Senior Planner Liz James
 Department of Planning, Housing, and Infrastructure

RE: FOKE Submission — Montefiore Seniors Housing SSD-98363228
19–25 College Crescent, and 15-19 Link Road, St Ives

Step 1 of PBP 2019 at page 14 (Figure 1.5, "Does PBP apply?") sets two independent triggers:

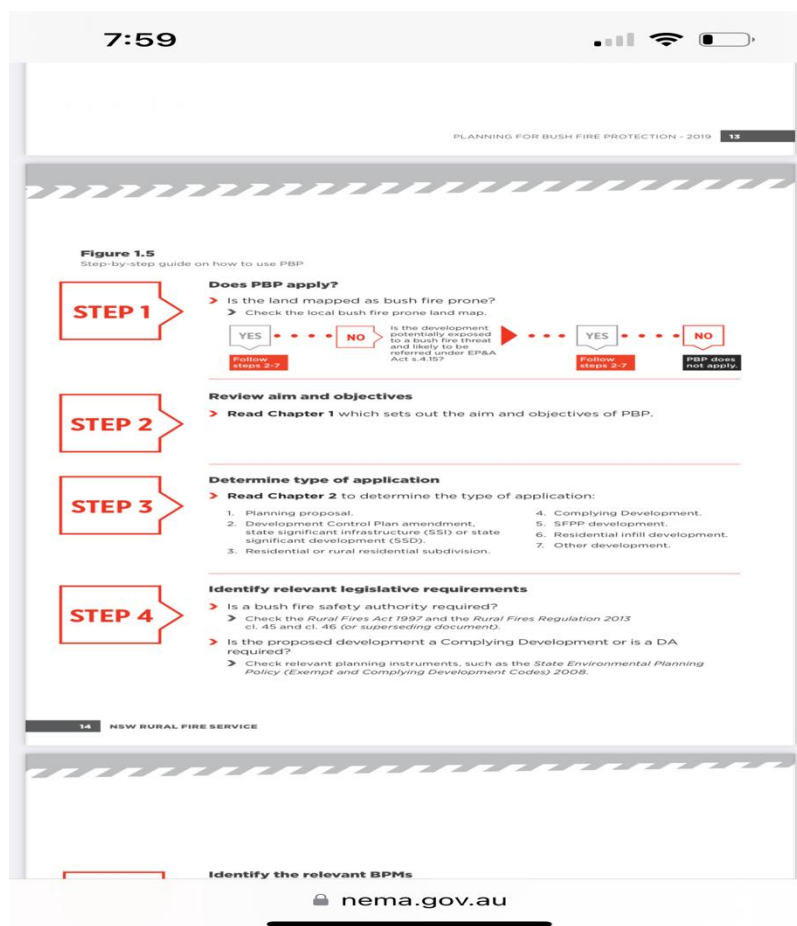
For a State Significant Development assessed in 2026, the "Planning for Bush Fire Protection" prescribed under section 4.14(1)(a) of the Environmental Planning and Assessment Act 1979 (NSW) is the version prescribed by clause 271 of the Environmental Planning and Assessment Regulation 2021 (NSW): **Planning for Bush Fire Protection 2019 (PBP)**, as amended by the addendum published in November 2022 and the addendum published in January 2025. That composite instrument has been in force since 4 April 2025.

Neither addendum amends Chapter 1 or Figure 1.5 of PBP 2019. The November 2022 Addendum is confined to Appendix B specific requirements for Special Fire Protection Purpose (SFPP) Class 9 buildings, aligning PBP with Specification 43 of National Construction Code 2022 (NCC). The January 2025 Addendum is narrower still, addressing only Class 9B primary and secondary school buildings. Chapter 1, Figure 1.5 and the Step 1 gateway therefore continue to operate as originally published in PBP 2019.
